TransGrid 2023/24 to 2027/28 Regulatory Control Period

REVIEW OF ASPECTS OF TRANSGRID'S REVENUE PROPOSAL (PUBLIC VERSION)

Report prepared for:
**AUSTRALIAN ENERGY
REGULATOR**
August 2022

Figure 3.4: Movement in proposed capex excluding PEC, excluding overheads \$m real 2022-23

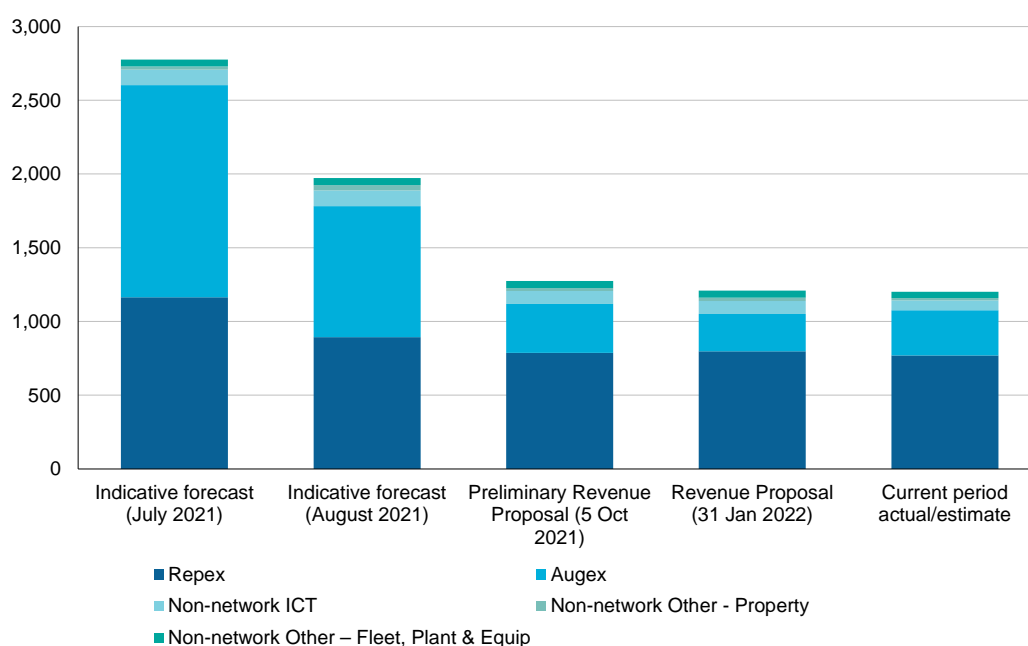
158. Following Transgrid's portfolio optimisation review, individual need expenditure was adjusted through a combination of typical methods. The results are shown in Figure 3.4 below.⁶¹

Figure 4.2: Total planned capex, including contingent ISP and NSW REZ projects, \$m 2022-23

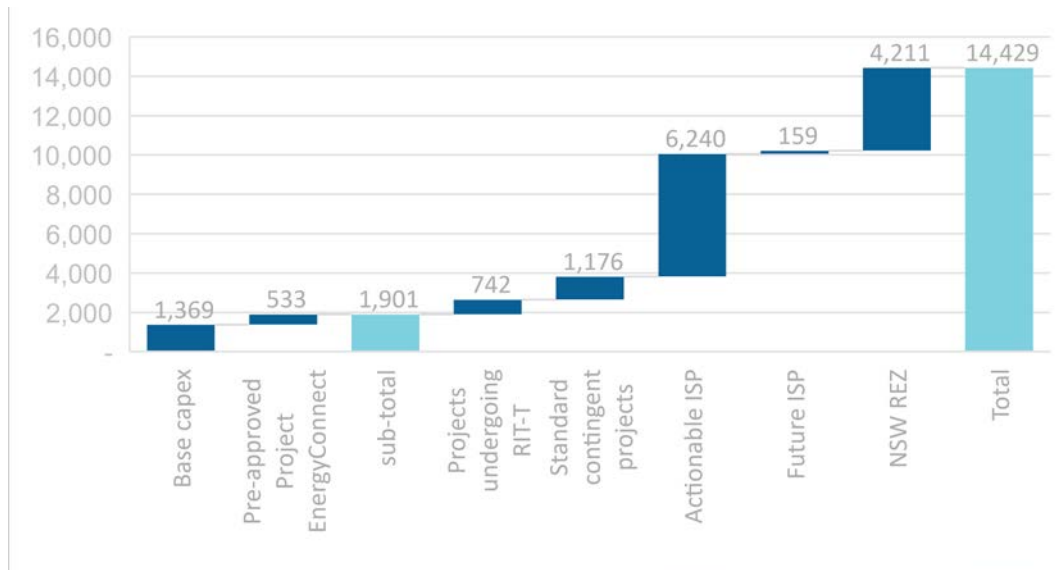
236. As shown in Figure 4.2 below, collectively this has the potential for \$14billion of capital investment within the next 5 years. This is far in excess of the \$1.9billion currently proposed in Transgrid's regulatory submission.

Figure 6.3: ICT totex per user

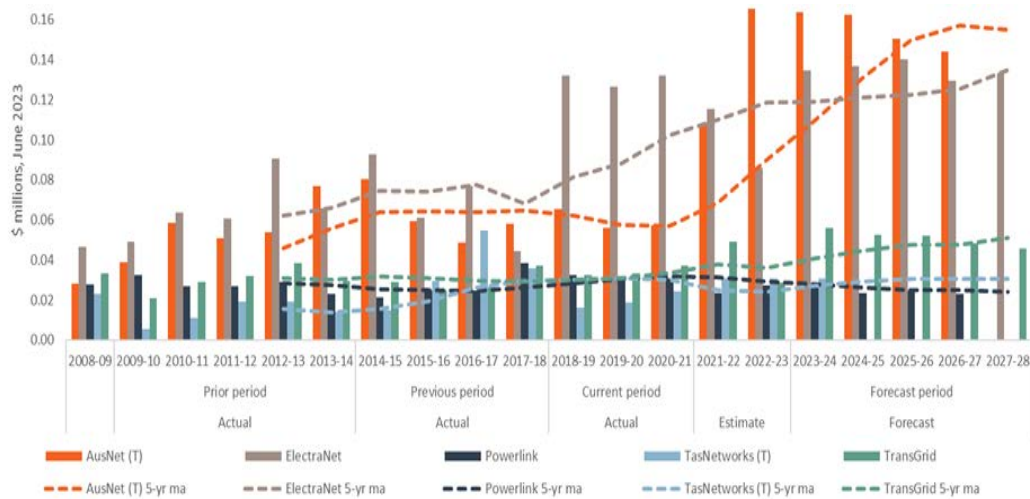
398. We have developed a benchmark comprising ICT totex per user from available RIN data, as shown in Figure 6.3. Overall, Transgrid benchmarks well against its peers – particularly against AusNet (Transmission) and ElectraNet – despite Transgrid’s totex per user trending up over the current RCP and at an increasing rate during the next RCP.

Figure 6.5: Transgrid’s ICT capex excluding SaaS-related expenditure (\$m, real 2022-23)

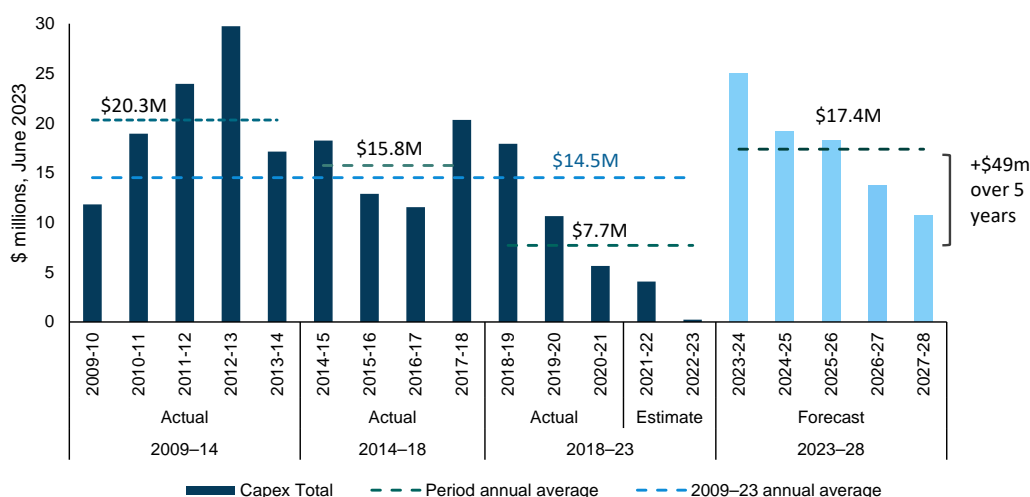
402. Transgrid proposes a 128% (\$49m) increase in ICT capex from the current RCP, after excluding SaaS opex. Transgrid proposes a material step increase in the expenditure profile in the first two years of the next RCP, despite its strategy of adopting cloud computing, where feasible.
403. The biggest increases are in the Bespoke Applications and Employee Enablement packages, both of which comprise on-premises investments.

404. As shown in Figure 6.5, the average annual capex over the current and previous regulatory periods is \$11.7m, which if used as a basis for the next RCP, would provide an indicative ICT capex forecast of \$58.3m. Allowing approximately \$14m for Transgrid to meet its new externally-driven cyber security obligations,¹⁶¹ would indicate a trend-based forecast of approximately \$72.3m, which is similar to the long-term average shown in Figure 6.5. However, this is \$14.6m (-17%) lower than Transgrid’s forecast.

Figure 6.6: ICT capex profile categorised as recurrent or non-recurrent expenditure (\$m, real 2022-23)

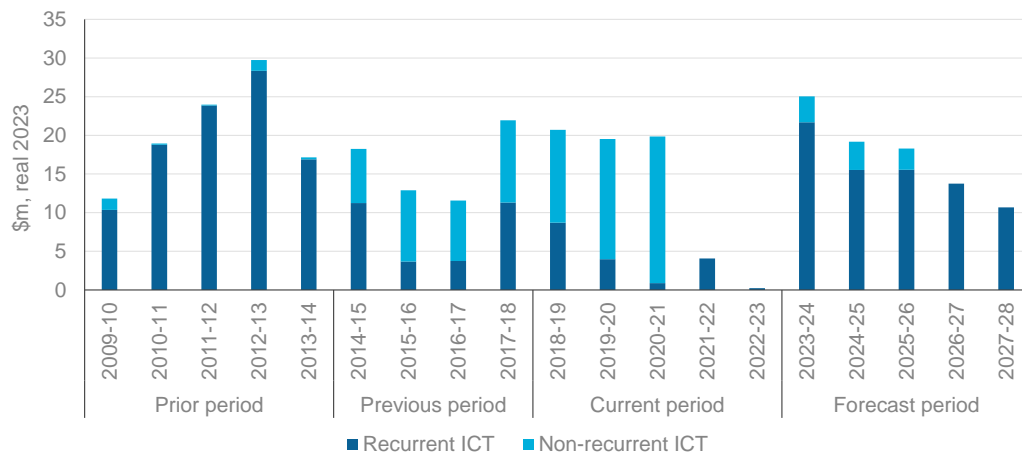
406. The trend of ICT capex by recurrent / non-recurrent expenditure classification is shown in Figure 6.6. It incorporates the IFRS SaaS reclassification for FY22 and FY23. It shows that the majority of proposed ICT capex in the next RCP is recurrent expenditure and is an order of magnitude higher than the recurrent capex in the current RCP. This is consistent with Transgrid’s own observation that it has focussed on replacing legacy systems in the current RCP, which satisfies the AER definition of non-recurrent capex.

407. As discussed in our assessment in section 6.3 of the prudence of the ICT capex packages underlying the expenditure profile shown in Figure 6.5, the low amount of recurrent capex in the current RCP followed by the proposed immediate ramp-up in recurrent expenditure in the next RCP is indicative of aligning expenditure with the regulatory period rather than investing for need. For example, for Transgrid’s Employee Enablement package, which covers the recurrent replacement of user devices such as desktops, laptops, tablets, and mobile phones:
